Agenda
Village of Arlington Heights
Design Commission
Community Room, 3rd Floor

Arlington Heights Village Hall
33 S. Arlington Heights Road
Arlington Heights, IL 60005
February 23, 2016
6:30 PM

**MINUTES OF
THE VILLAGE OF ARLINGTON HEIGHTS
DESIGN COMMISSION MEETING
HELD AT THE ARLINGTON HEIGHTS MUNICIPAL BUILDING
33 S. ARLINGTON HEIGHTS RD.
FEBRUARY 9, 2016**

REAR ELEVATION
 SCALE 1/8"=1'-0"

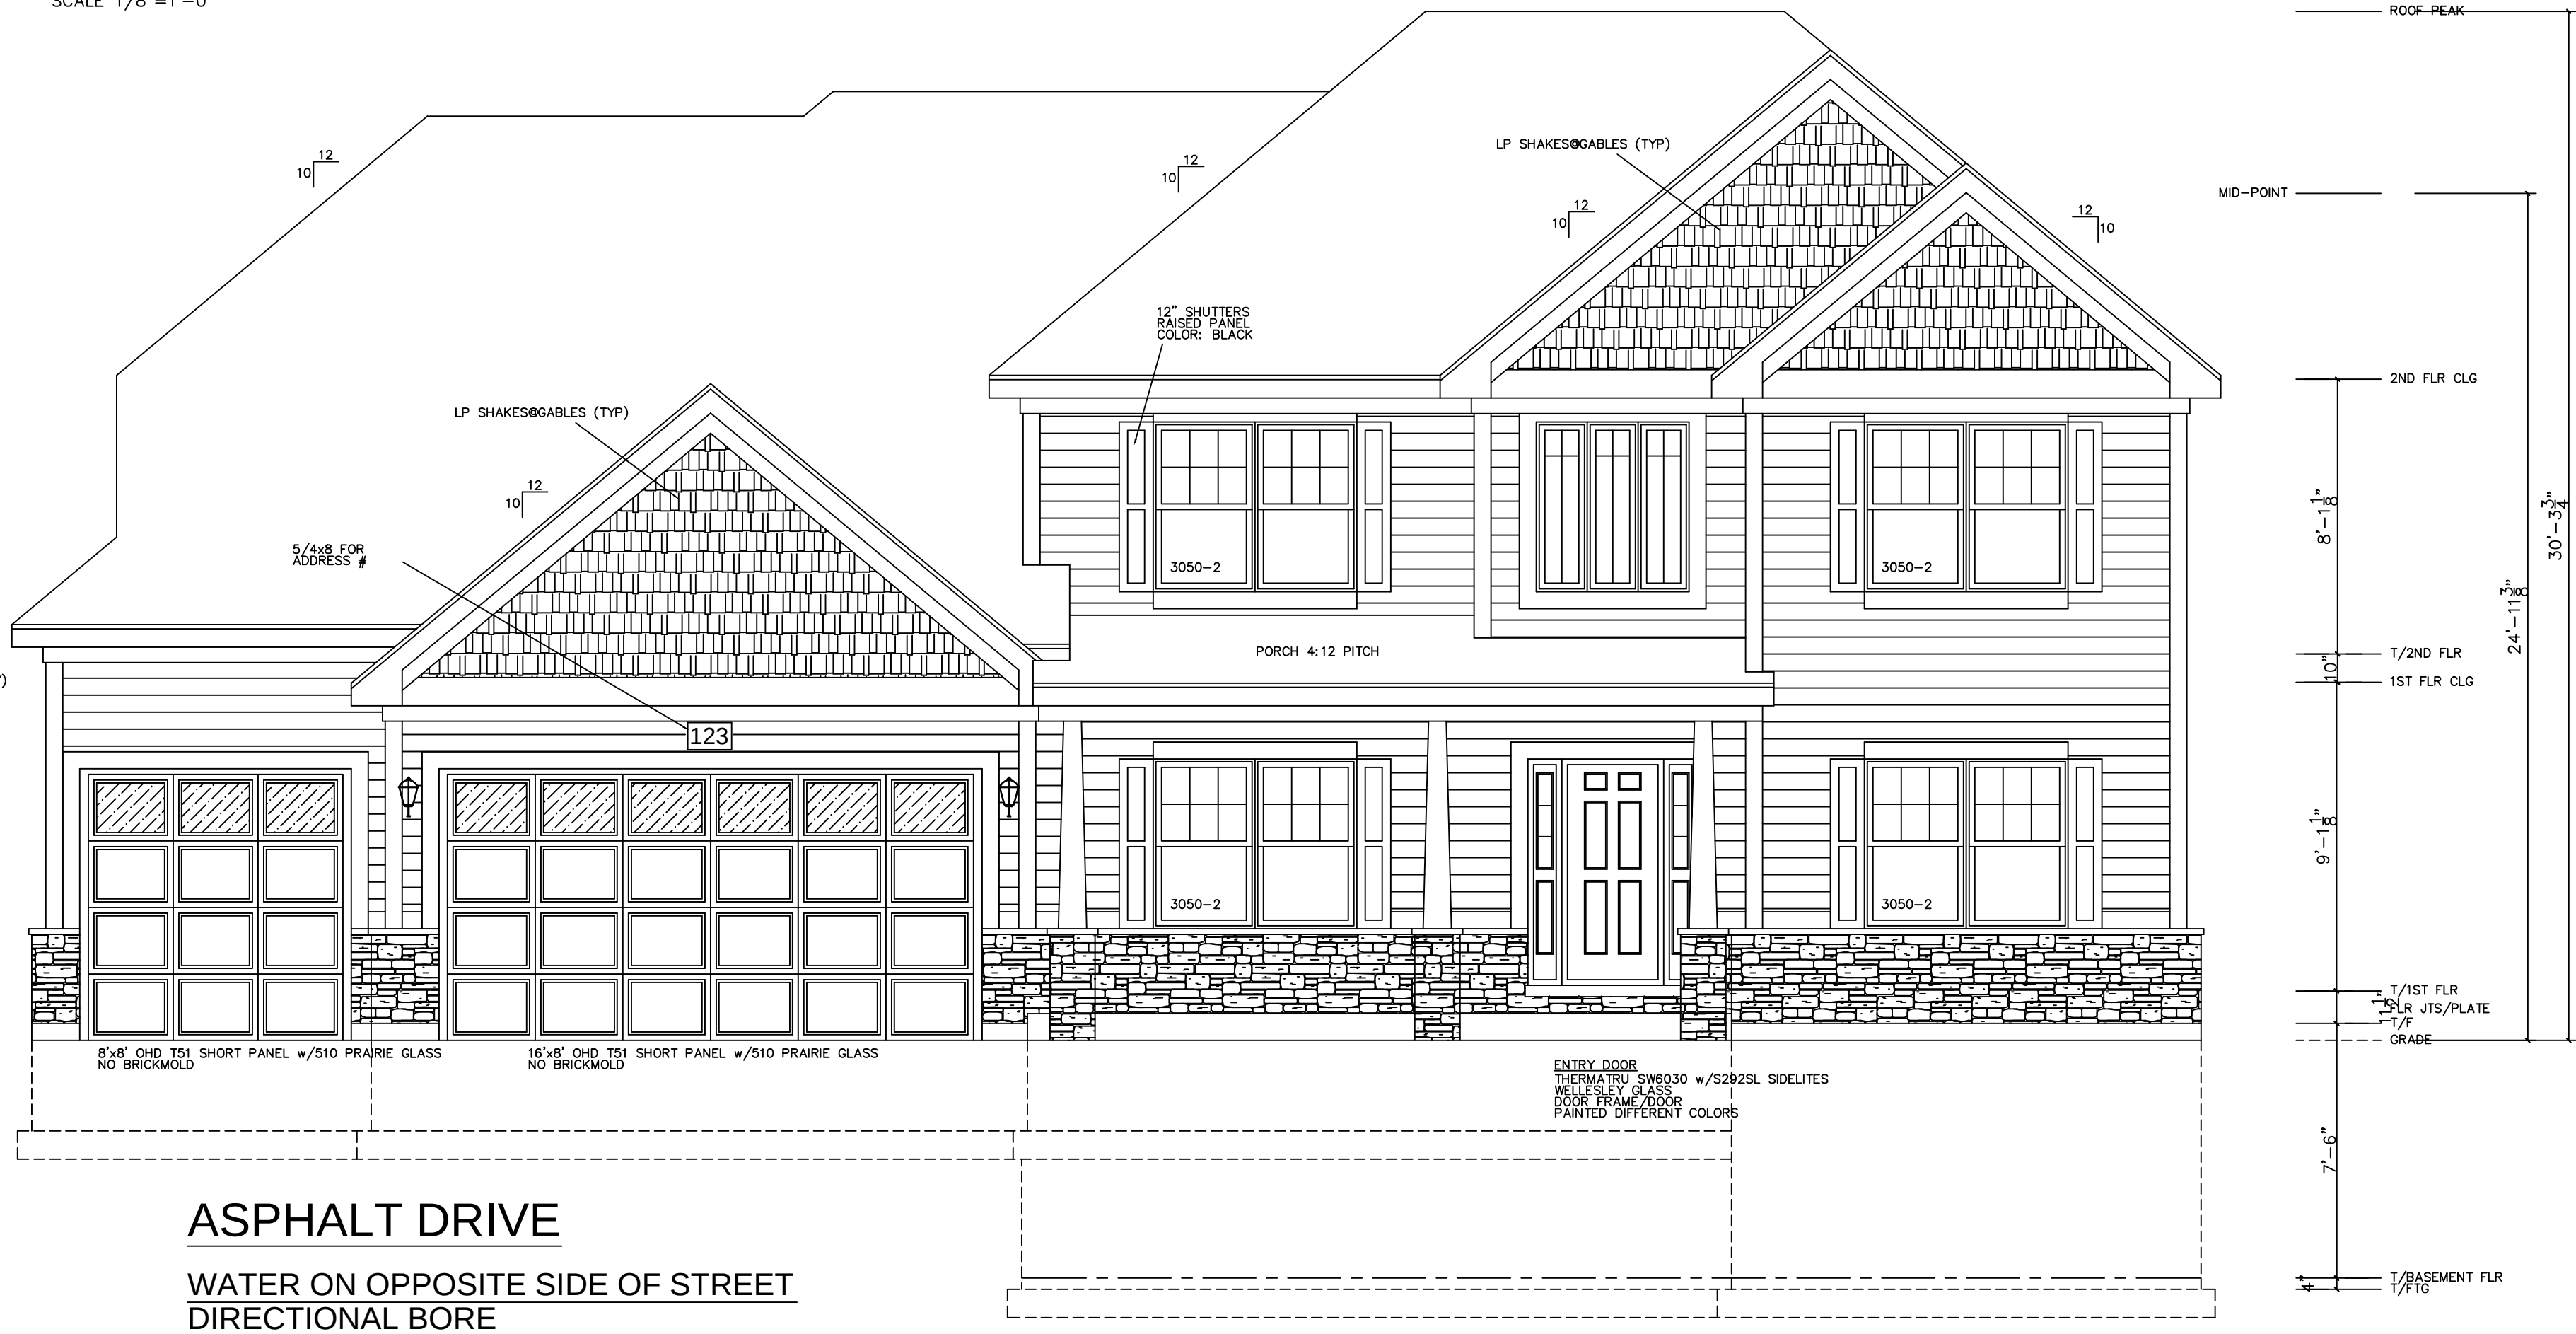
The overall style and character of the proposed home will fit in very well with the existing adjacent newer home at 401 N. Gibbons. The front wall of the house and porch are in front of the garage which keeps the design emphasis on the main part of the house instead of on the garage. However, the three car garage is wide, and the roof area above the garage is large and a bit dominating. Additionally, the lack of detail on both side elevations should be improved.

- a. It is recommended to continue the stone base to the back corner of the garage, and add a window in the side of the garage with decorative window shutters to match the front elevation.

3. Right (side) Elevation:
 - a. It is recommended to continue the stone base to the back corner of the house, and add at least one window with decorative window shutters in each of the main rooms (Living Room, Study, Bedroom 3, and Bedroom 4) to match the character of the front elevation.

4. General:
 - a. Provide decorative window grilles in all windows on the side and rear elevations to match the front of the house.

4. Add a window in the side of the garage with decorative window shutters to match the front elevation.
5. Continue the stone base to the back corner of the house on the right side elevation.

6. Add at least one window with decorative window shutters in each of the main rooms on the right side elevation (Living Room, Study, Bedroom 3, and Bedroom 4).

7. Provide decorative window grilles in all windows on the side and rear elevations to match the front of the house.
8. This review deals with architectural design only and should not be construed to be an approval of, or to have any other impact on, any other zoning and/or land use issues or decisions that stem from zoning, building, signage or any other reviews. In addition to the normal technical review, permit drawings will be reviewed for consistency with the Design Commission and any other Commission or Board approval conditions. It is the architect/homeowner/builder's responsibility to comply with the Design
